11722A-01

ADMINISTRATIVE INFORMATION

Figure 1

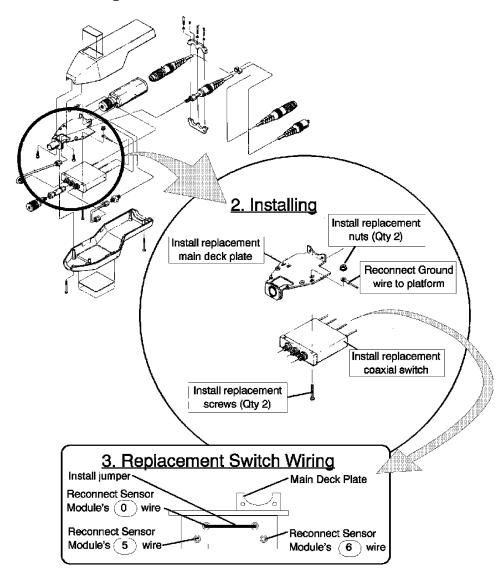
Replace original Main Deck Plate (MP1) and associated hardware with part numbers noted above. Refer to Figure 1 for correct mechanical and electrical connections. Recalibration and generation of Calibration Factors for the Sensor Module is recommended after coaxial switch replacement.
